Document number
BGLI08:494
Date
2008-06-05
Remarks

Revision
A

HW change description for

Mobile Station Type:
AAD-3252041-BV W760i
HW (B)

2.1 Antenna Element Change

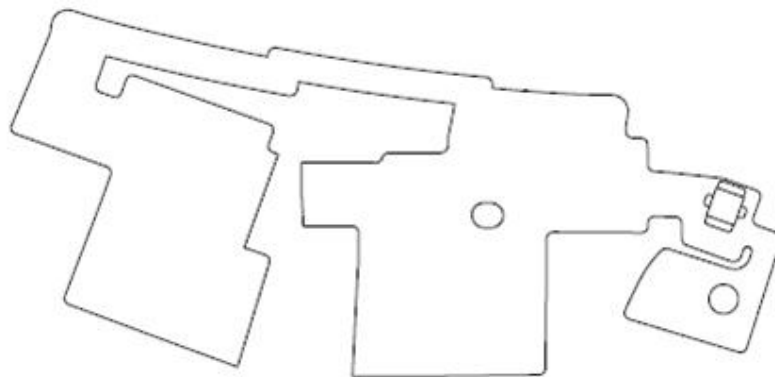
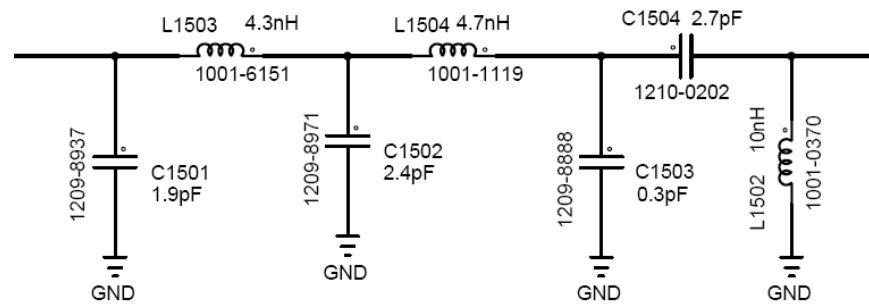
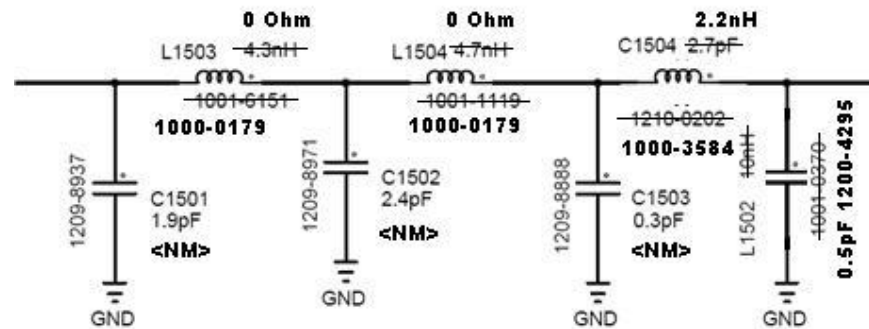
Note the array of components surrounding the larger coax connector. These were intended to be used for a “pre-distortion” matching circuit between the antenna element and the coax cable.

For HW-B, the element shape has changed and the pre-distortion matching circuit has been eliminated.
